SB-10055387-7764

Campaign No. 2013120001, December 2013

SUBJECT: **Model 207 (E-Coupe), Model Year 2013**
Rework Seam Seal at Left Tail Lamp

Figure 1

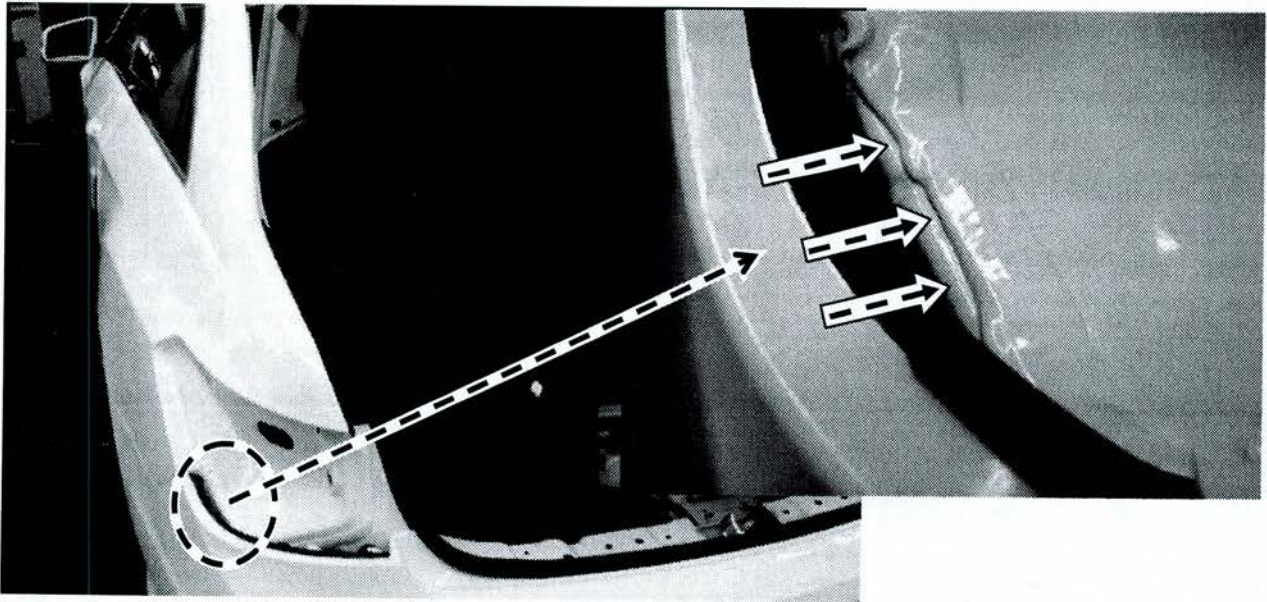
This Service Campaign has been initiated because Daimler AG (DAG), manufacturer of Mercedes-Benz vehicles, has determined that the seam seal at the left rear tail lamp may not be to specification possibly allowing moisture to enter the trunk. To correct this condition, an authorized Mercedes-Benz dealer will rework the seam seal at the left rear tail lamp at the next workshop visit.

- Be careful not to damage tail lamp seals when removing tail lamp.
2. Thoroughly clean seal seam and then degrease with silicone remover (shop supply).
 3. Apply missing sealant (arrows, Figure 1).
